MeshSat field kit V2, Option A(i) lid pack: sheet A1-1 arrangement B in plan: the lid module, the QMX set and every face part under the lid

MESHsat-1357, stream a1mech, 29 Sep 2026. Case frame: X east, Y toward the hinge (back) wall, Z up from the base floor, lid closed. mm. Prototype design, AI review: nothing built, bought or fitted; analytical success is not physical verification.

MeshSat field kit V2, Option A(i) lid pack: sheet A1-3 the arrangements that fit, and the owner decision

MeshSat field kit V2, Option A(i) lid pack: sheet A1-5 mass and open-lid stability

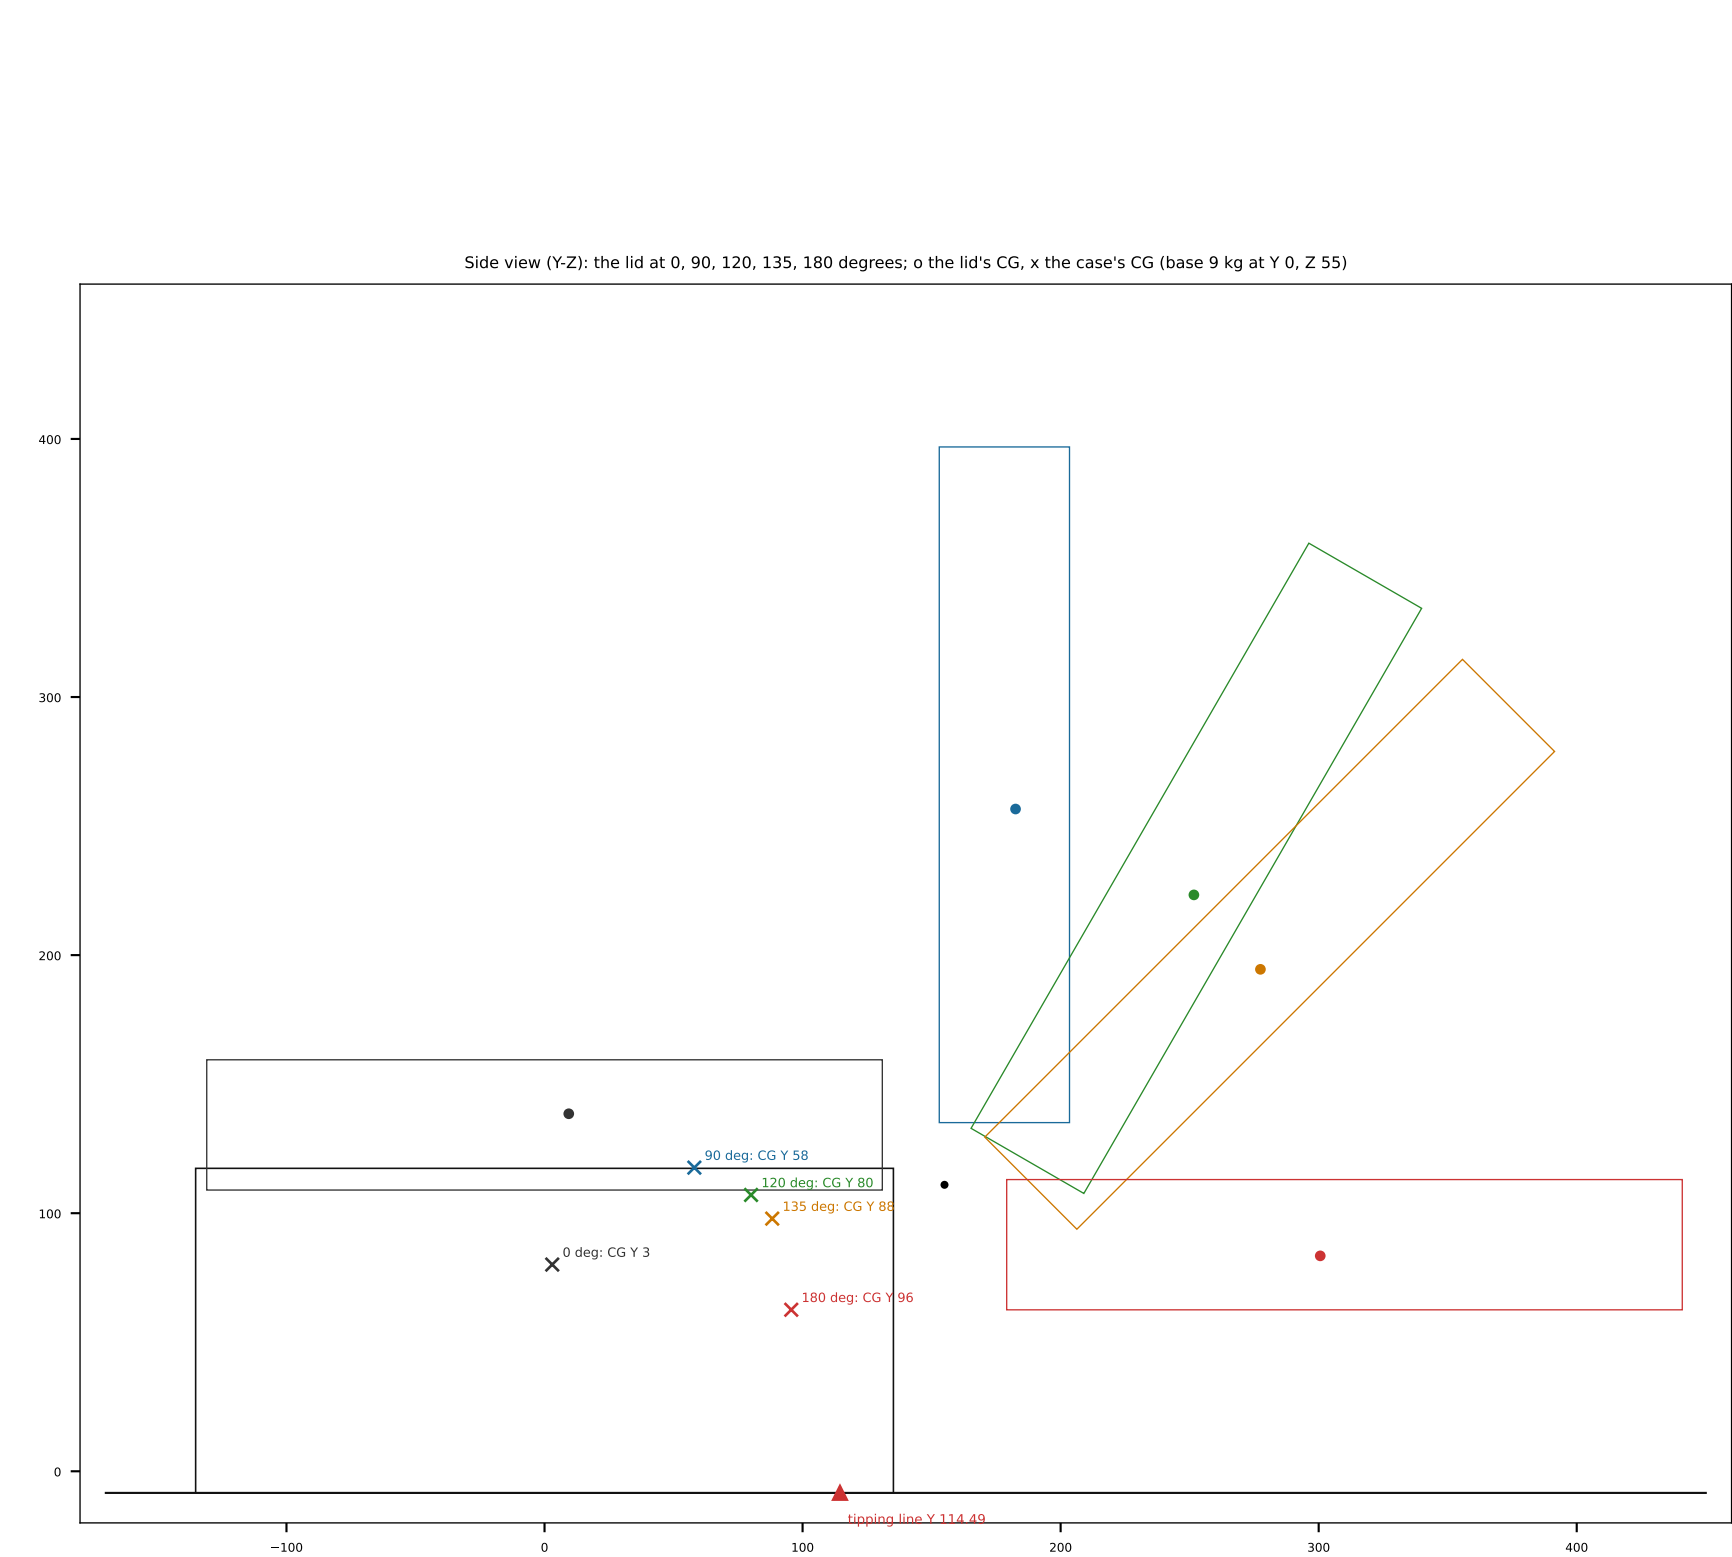
WORST OVER THE SWEEP (base 7..14 kg, CG Y -20..+20, Z 45..65, hinge axis Y 147..163): critical back slope, deg			
lid open	B	A	
90	14.9	17.1	
100	11.6	14.0	
110	8.4	11.1	
120	5.4	8.4	
135	1.3	4.9	
150	-2.2	2.2	(tips on level ground)
180	-5.0	1.7	(tips on level ground)

VERDICT: stands on level ground to 120 degrees of opening in every swept case; a light base tips from 135. FIX (SESSION, reversible): a lid stay stopping the lid at 100 degrees (webbing strap between two bonded anchors, lid back wall and plate back band; no hole; about EUR 10, ESTIMATE). With it the open case stands on a slope of about 10 degrees at the worst (lid_pack_a1.out section 4). The stop angle, the hinge axis and the case's CG are read on the mock-up (T-A1-3); Peli states no load for its hinges (T-A1-4).

MeshSat field kit V2, Option A(i) lid pack: sheet A1-6 the base pockets: section 8's 4S6P at the same worst figures

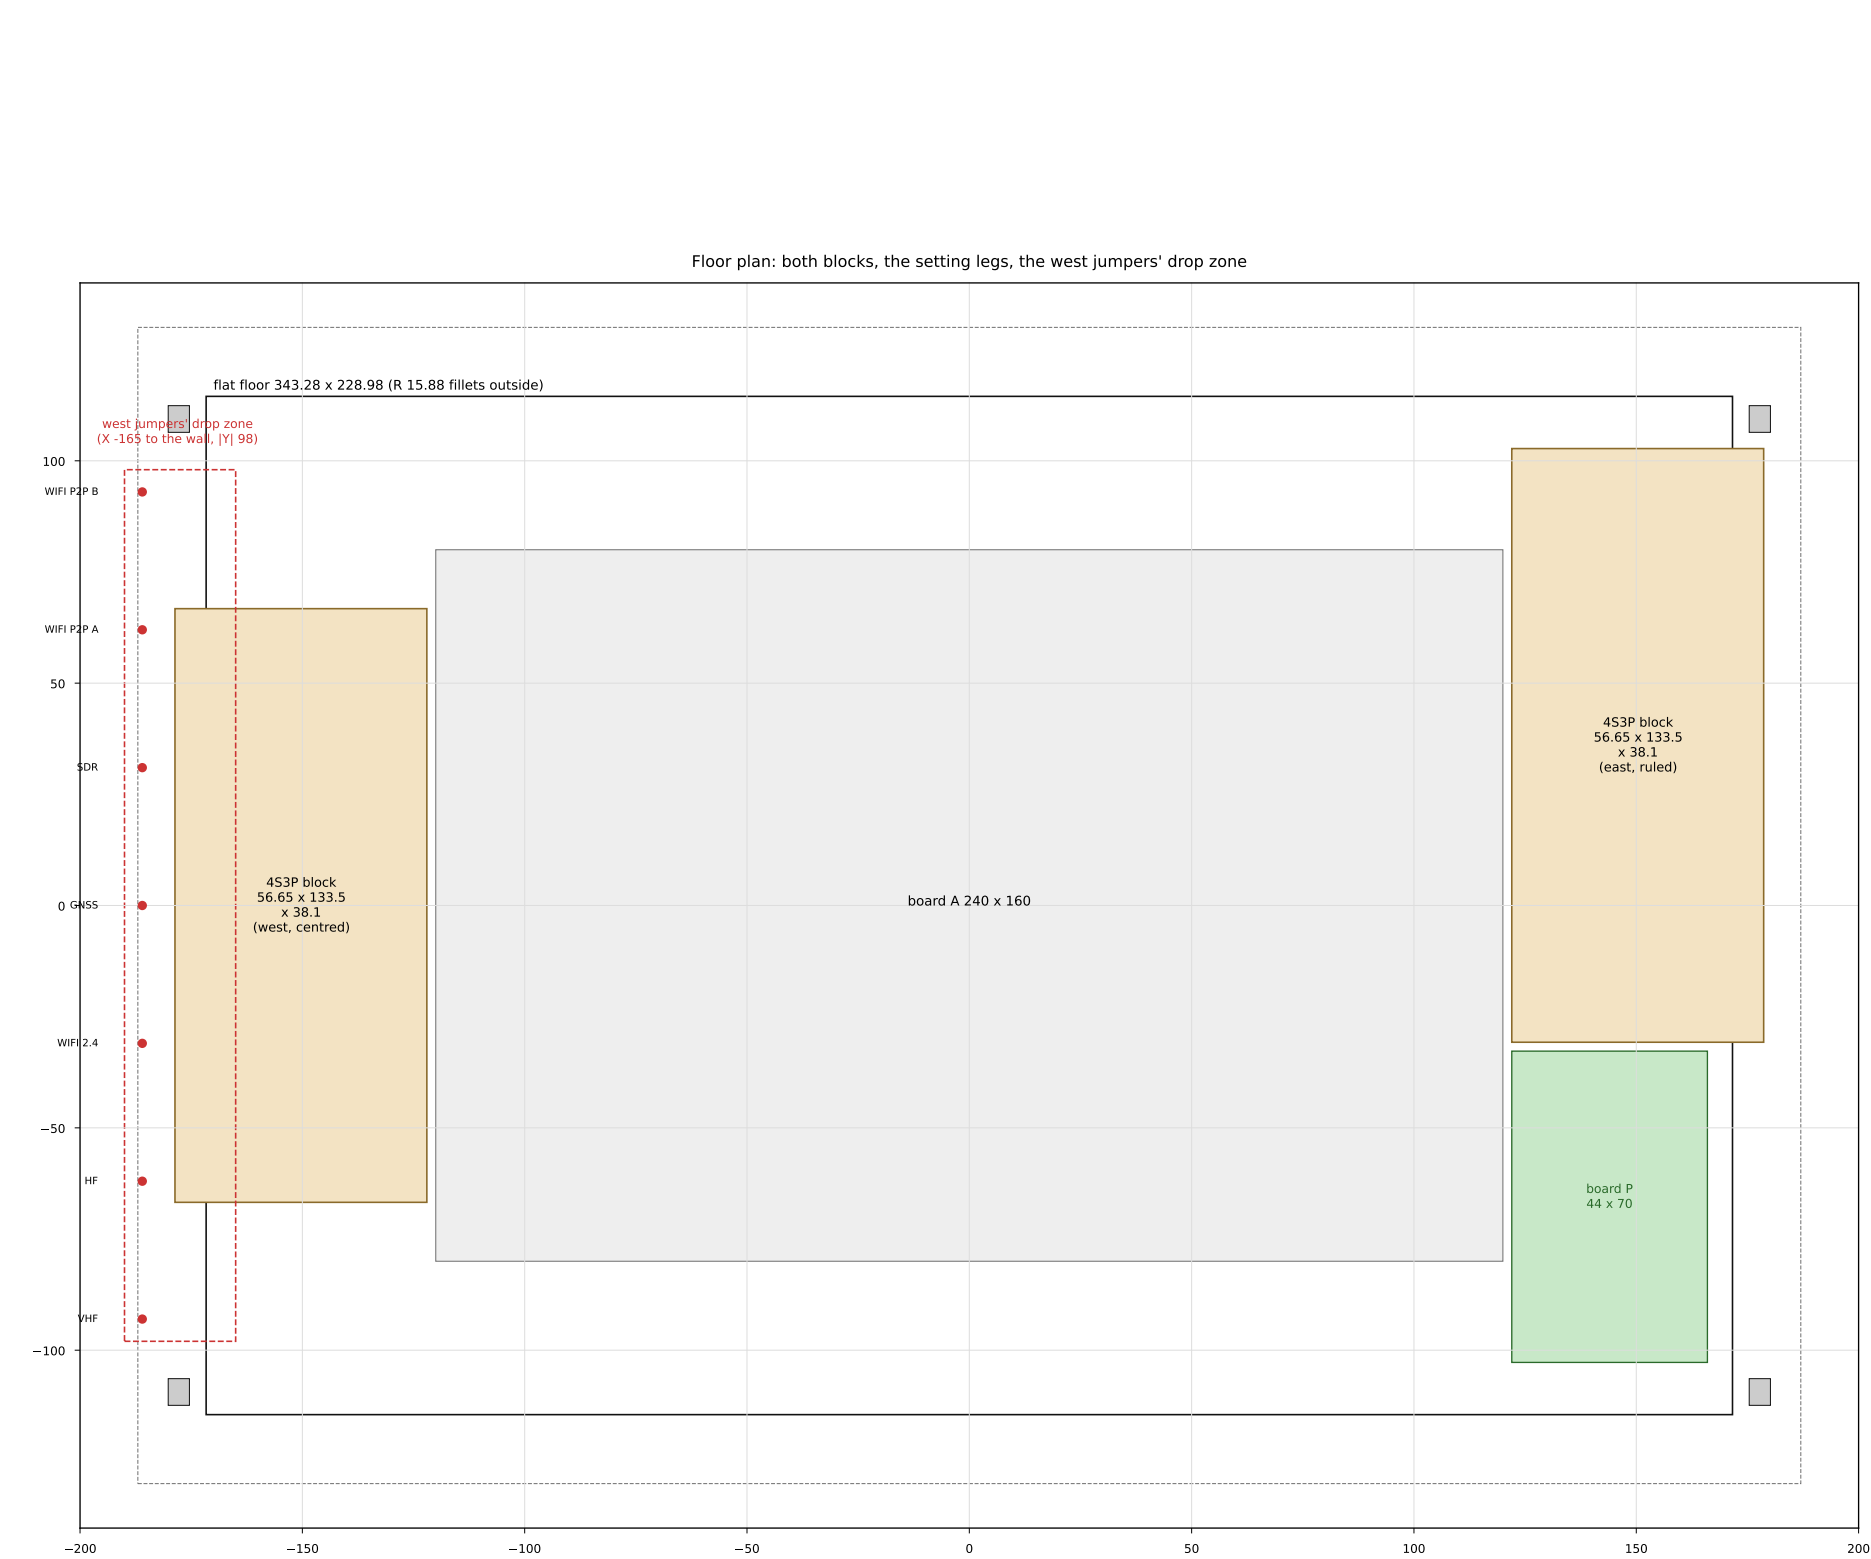
ROW	worst	x2	verdict
M4a	1.85	0.85	OPEN: placed by hand; T4
M4aw	1.85	0.85	OPEN: placed by hand; T4 (mirror: Peli's cavity and
M4b	7.38	6.38	MET
M4bw	7.38	6.38	MET (mirror: Peli's cavity and the RF entry plates a
M4c	3.18	1.80	MET
M4cw	3.18	1.80	MET (mirror: Peli's cavity and the RF entry plates a
M5	1.77	0.27	OPEN: placed by hand, the legs' locator; T4
M5w	37.77	36.89	MET (the block's Y place is not ruled; centred here)
M6	3.66	2.90	MET
M6w	3.99	n/a	OPEN: the x2 reading is not computed by A06's tool;

WEST RF JUMPERS: 5 of 7 west cables (Y -62, -31, 0, 31, 62) fall onto the west block; the slot over it is 7.19 at the worst less C33's zone (3.99); the only drop east of it is its 2.0 gap to board A, under one RG-316 (2.49): FAILS AS ASSUMED, held OPEN (section 8b, the M17 class): the west RF entry is re-planned before the west block is taken. Hold-down S-27 open for both blocks.
